Ad Hoc Committee Agenda Item #:	II A – Action Item
Date:	January 23, 2020
To:	Magnolia Educational & Research Foundation dba Magnolia Public Schools (“ <b>MPS</b> ”) Ad Hoc Committee (the “ <b>Committee</b> ”)
From:	Alfredo Rubalcava, CEO & Superintendent
Staff Lead:	Patrick Ontiveros, General Counsel & Director of Facilities
RE:	MSA-1 Change Order Requests

Staff recommends and moves that the Ad Hoc Committee approve change order requests 37 to 54 up to \$176,614.96 as presented by Oltmans Construction Co. (“**Oltmans**”) for the new construction project for the benefit of MSA-1 at 18220 Sherman Way (the “**Project**”) with the payment amount to be confirmed by MPS Staff based on a review of all change order requests and back-up.

Oltmans Change Order Requests

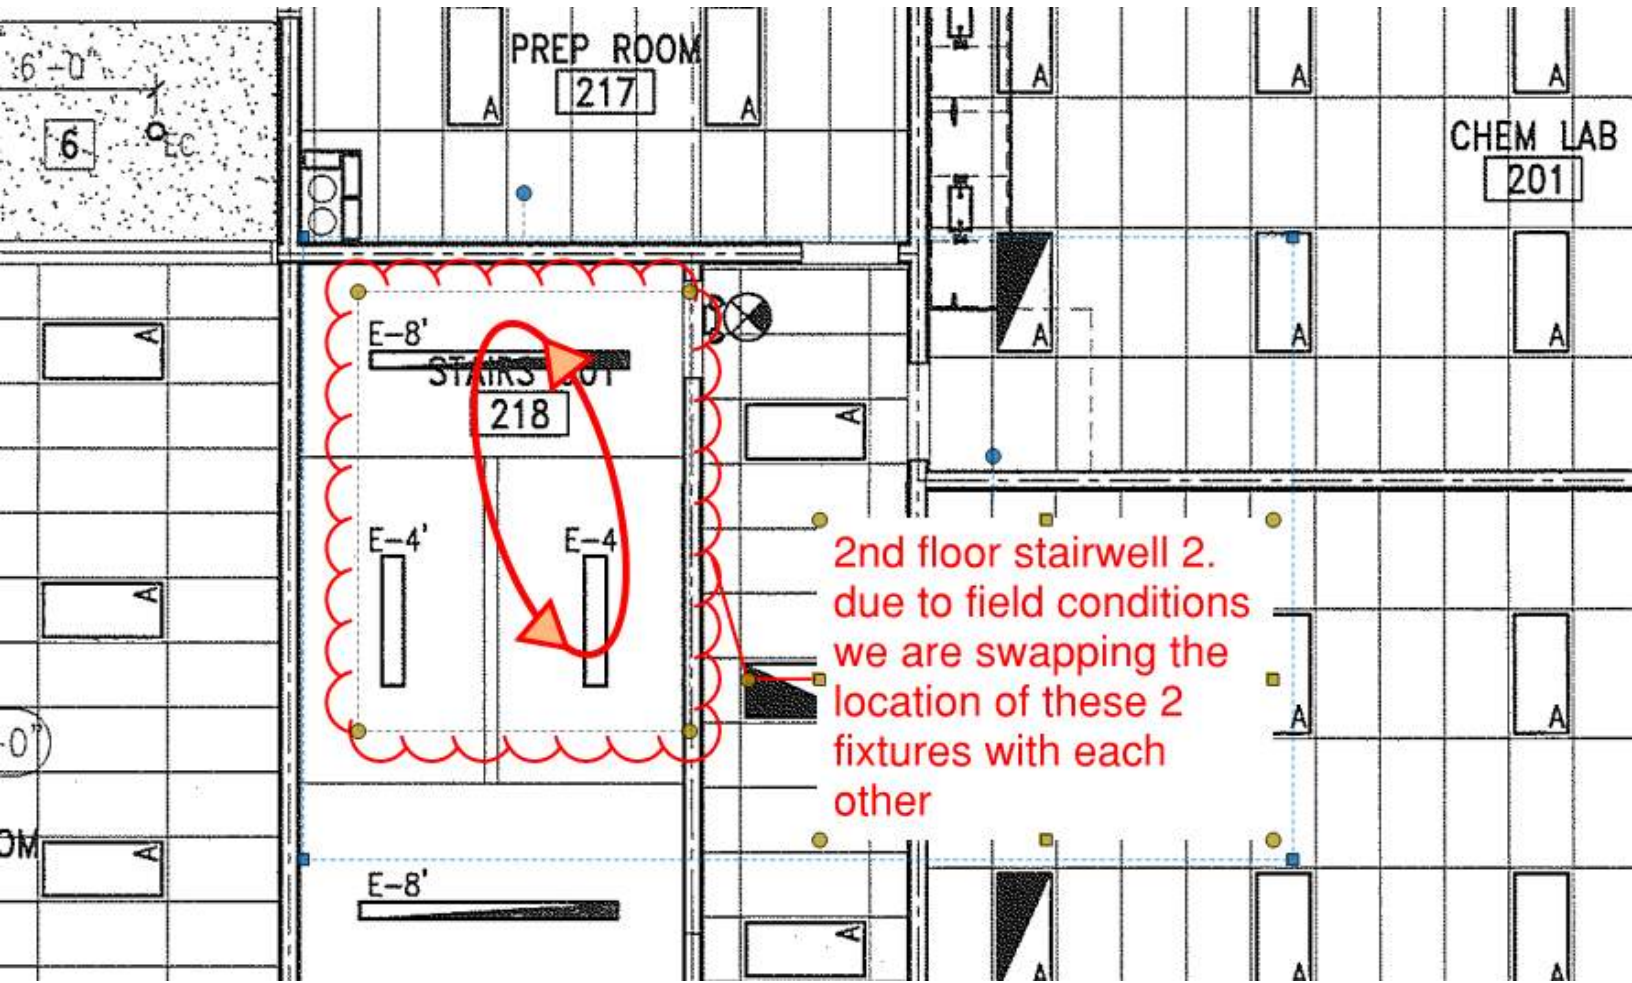
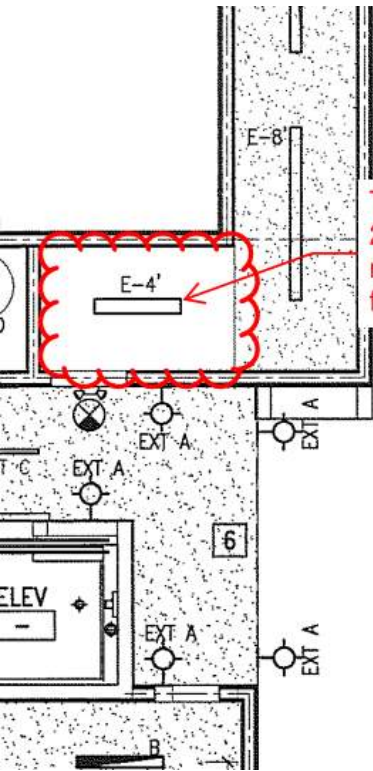
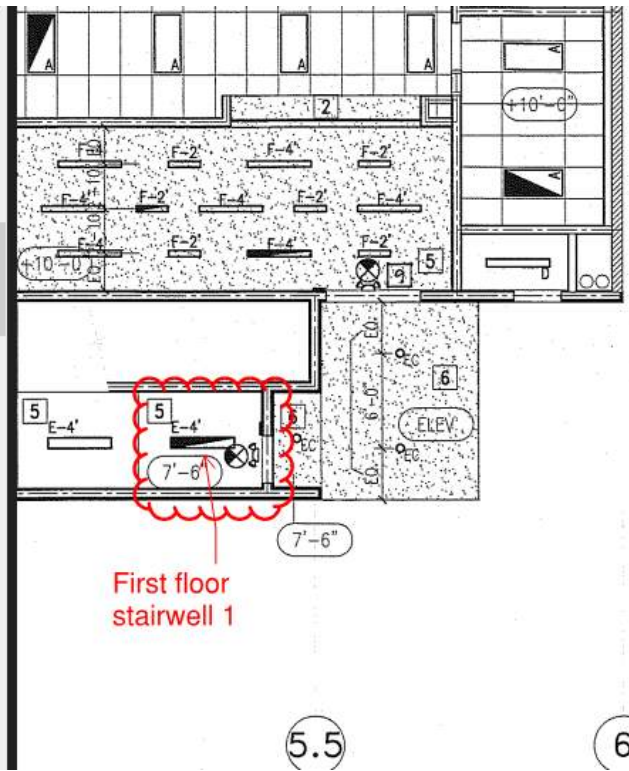
Please provide mounting clarification for the E4 fixtures in the stairwells (sheets E3.1 & E3.2). The prints show the fixtures to be mounted on the underside of the steel stairs. Attached is a photo showing the field conditions that are typical for both stairwells. In the photo you can see the all Steel Stairs are surrounded by Beams and Gluelams.

2nd floor stairwell 2.  
due to field conditions  
we are swapping the  
location of these 2  
fixtures with each  
other

This 3rd floor stairwell  
2 - 4' fixture will  
relocate to the 1st  
floor stairwell 1

**SUBJECT:** Top Plate CMST12 Strap  
**PROJECT:** Magnolia Science Academy

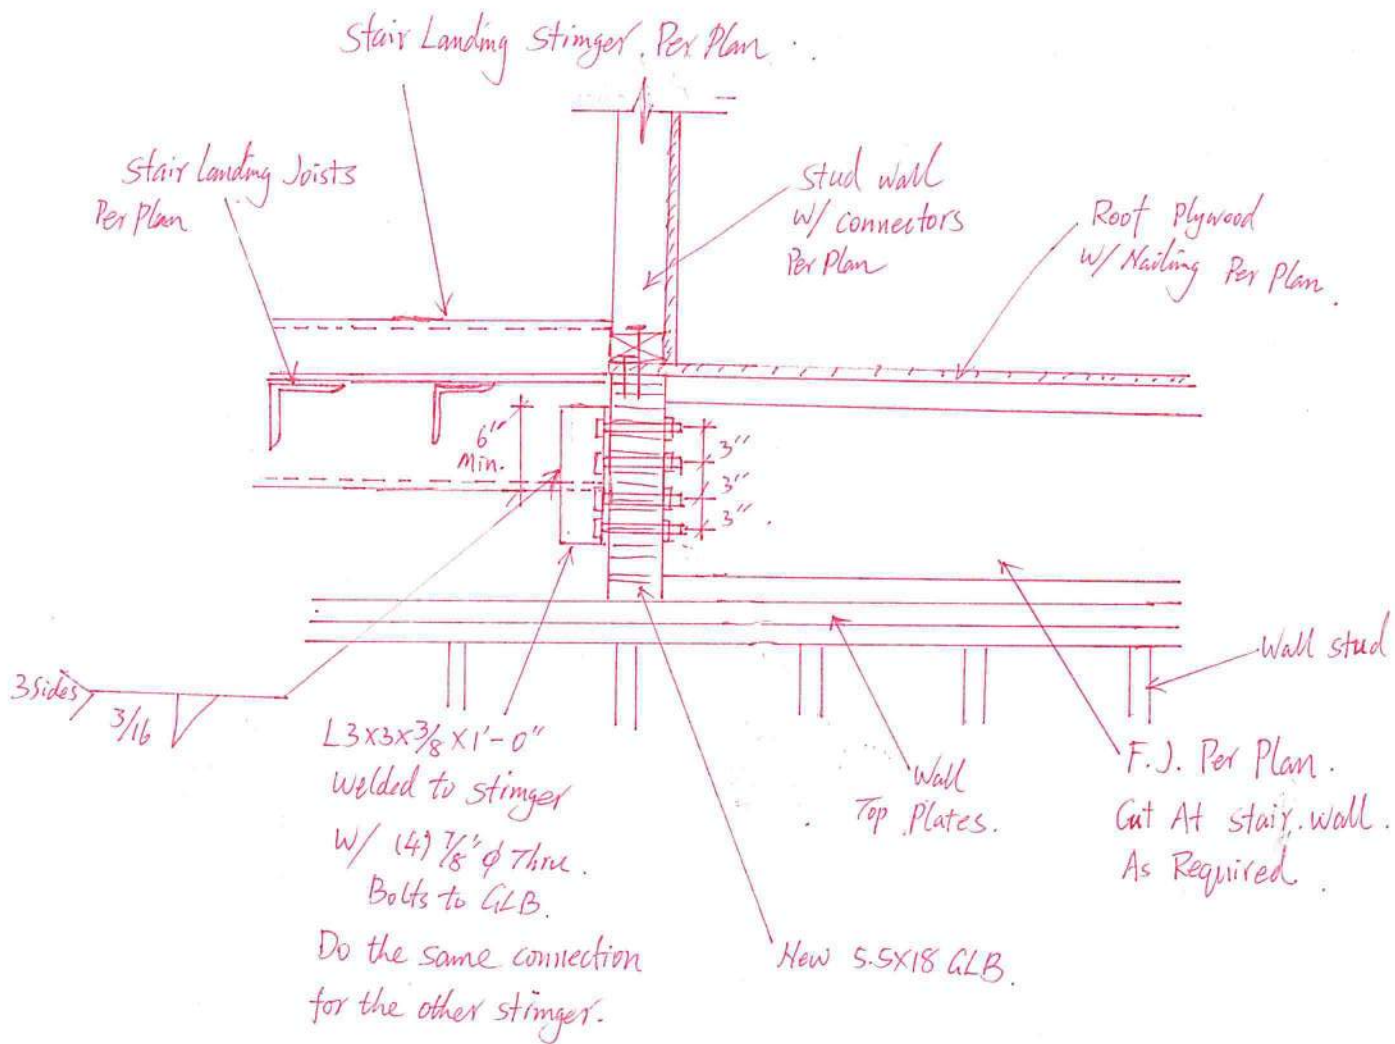
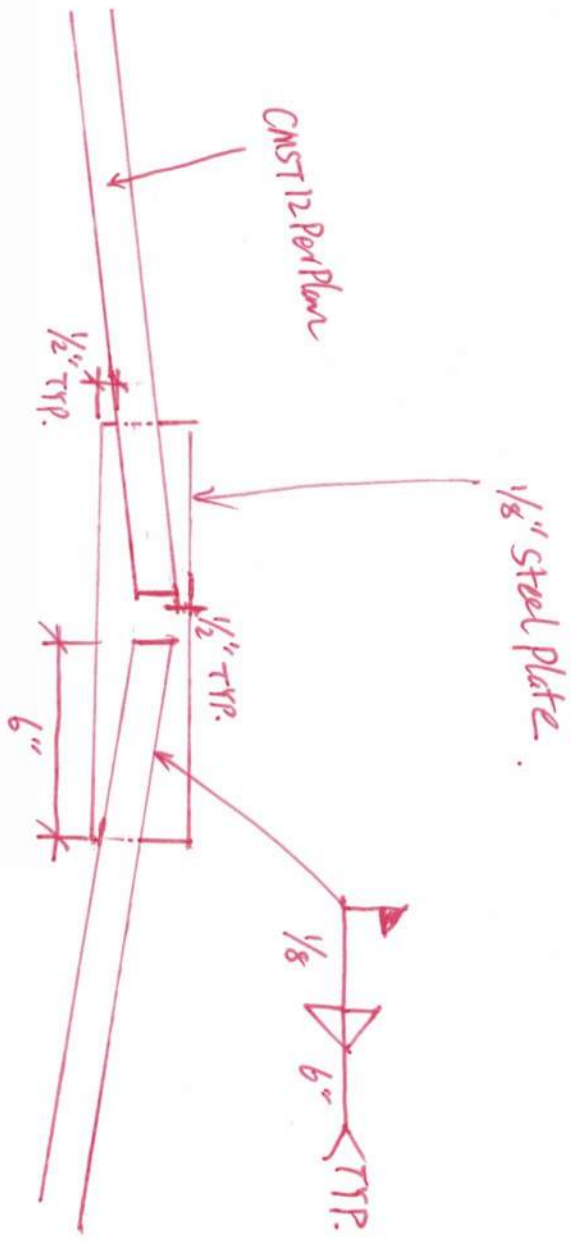
Sheet S 7.1 detail 6 calls out for a CSMT 12 strap, see attachment, this strap cannot be installed on the side of the top plate due to the required roof pitch. The strap cannot be bent to match the pitch. Please advise.

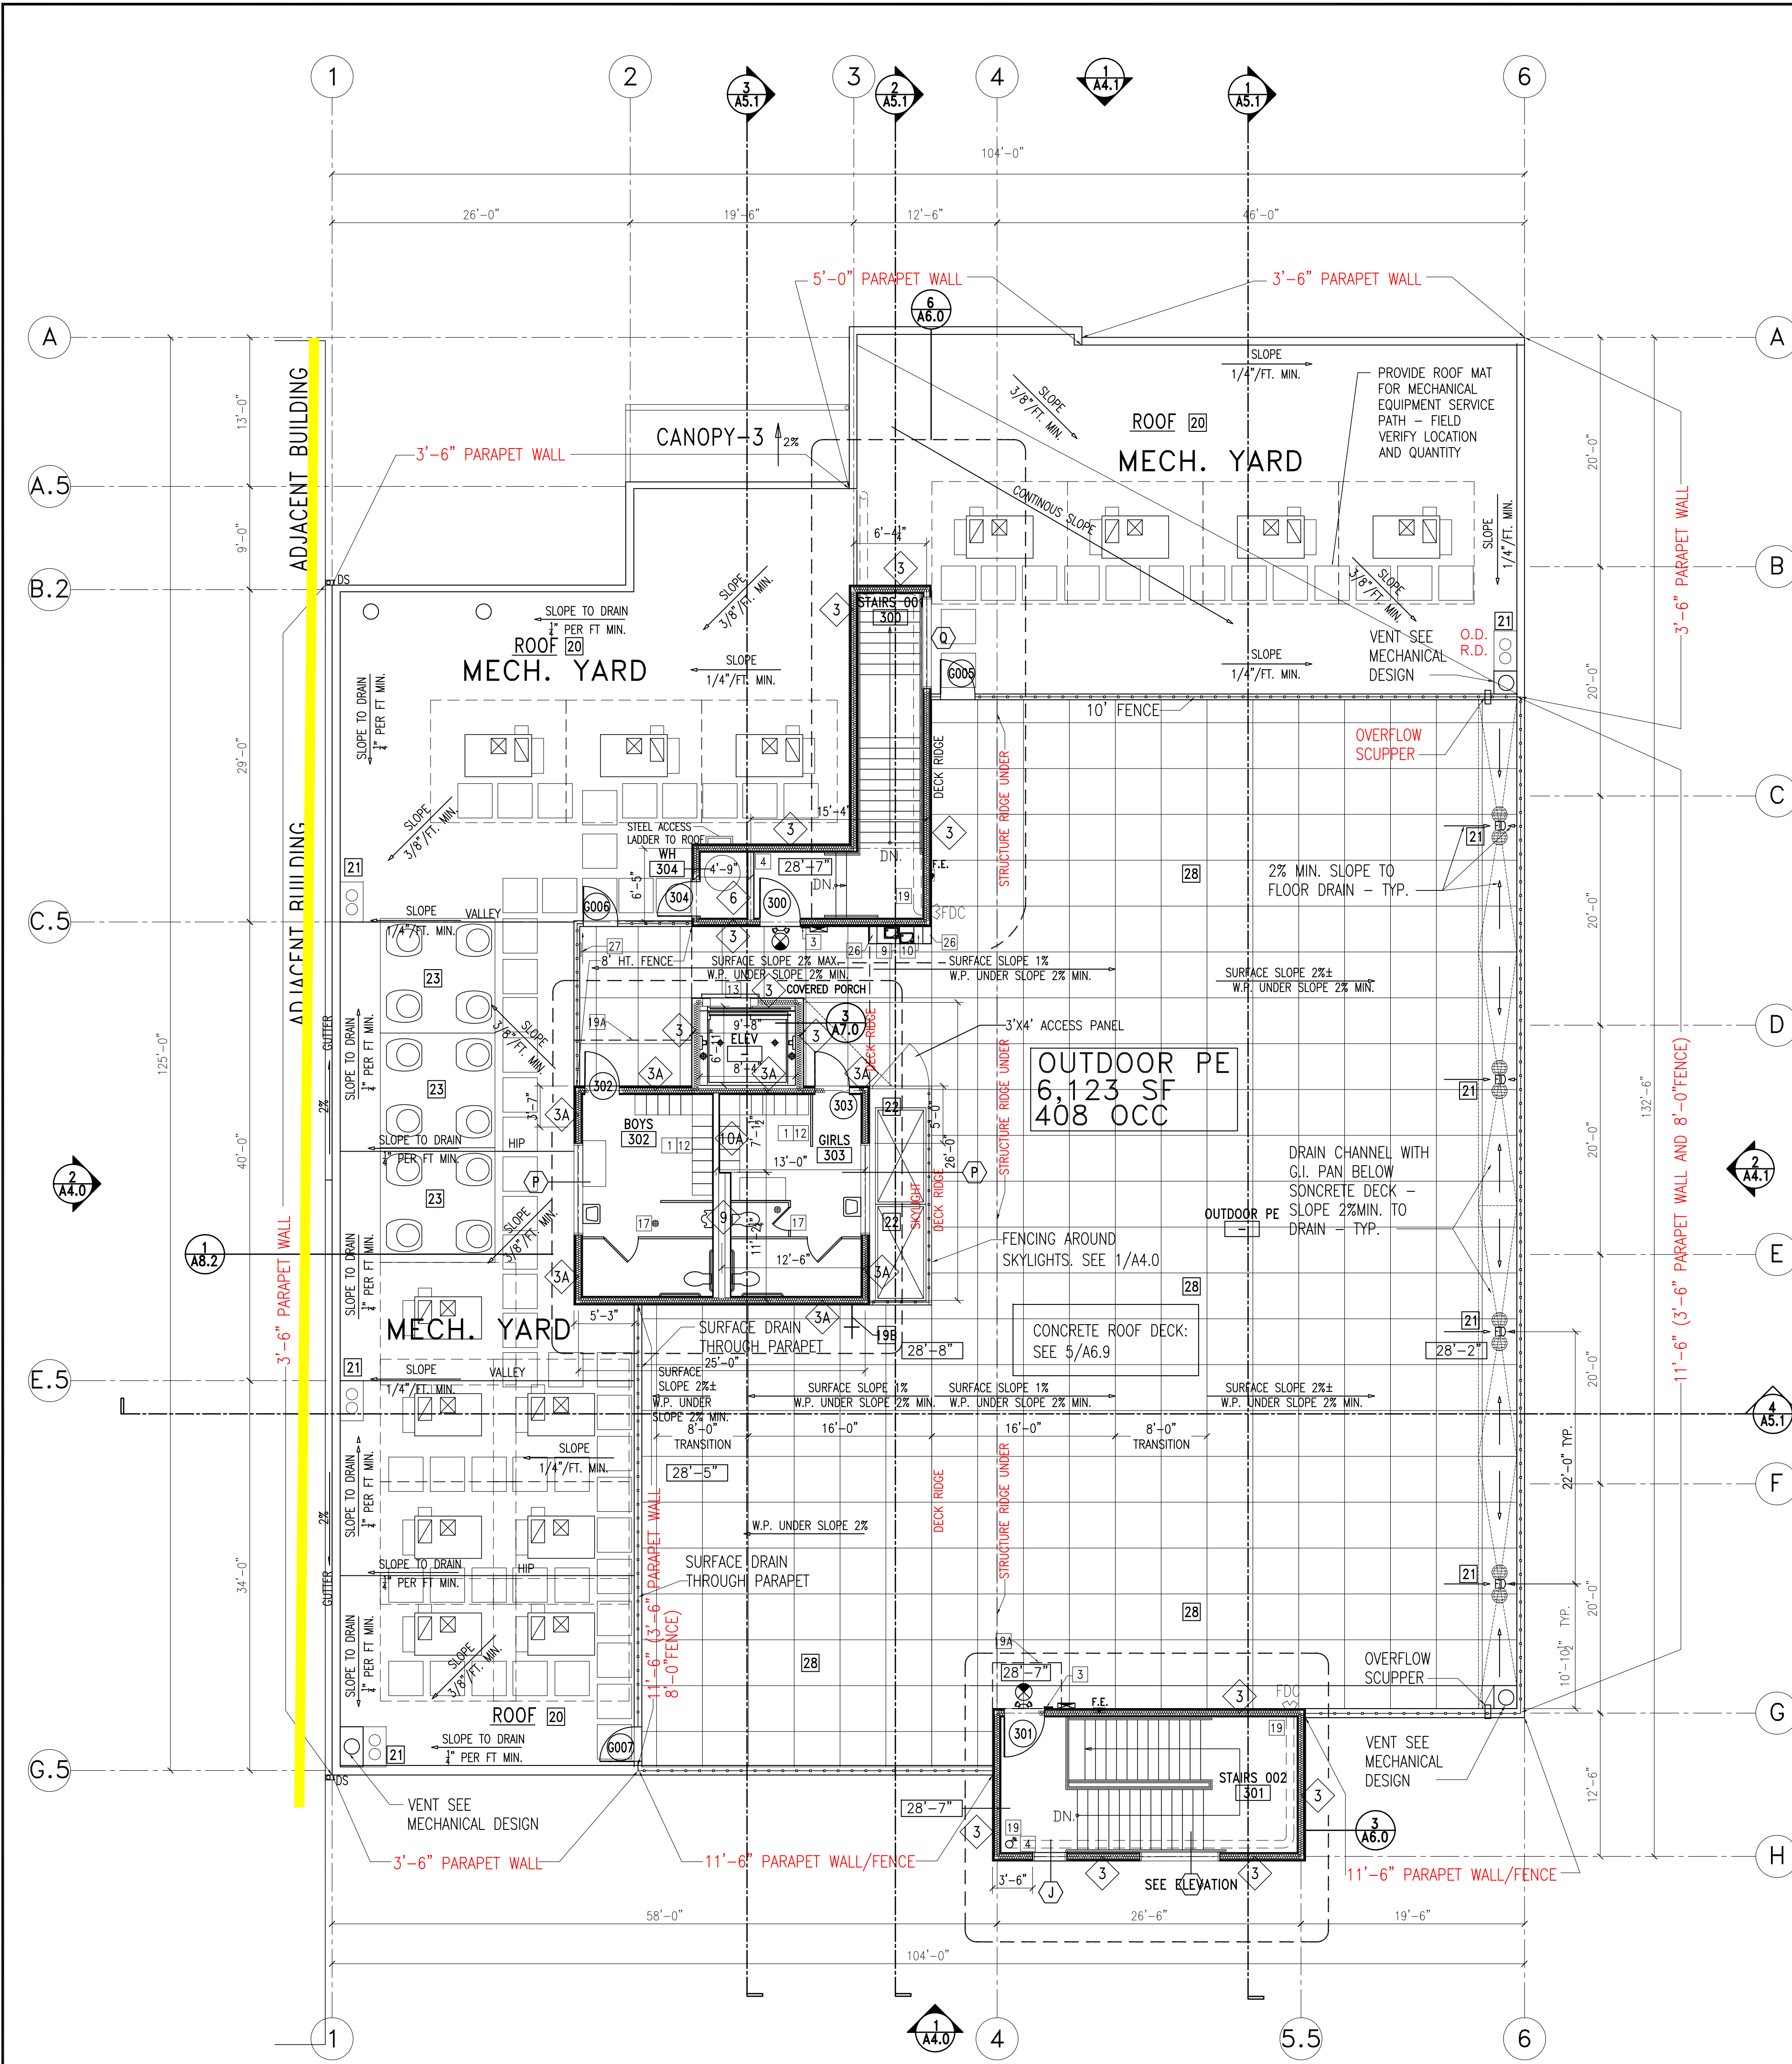
- Building to building flashing @ G/L 1 PP A3.1 as per bulletin 1&2 in lieu of gutter
- Credit for Gutter - @ G/L 1 PP A3.1

see attached highlighted plan.
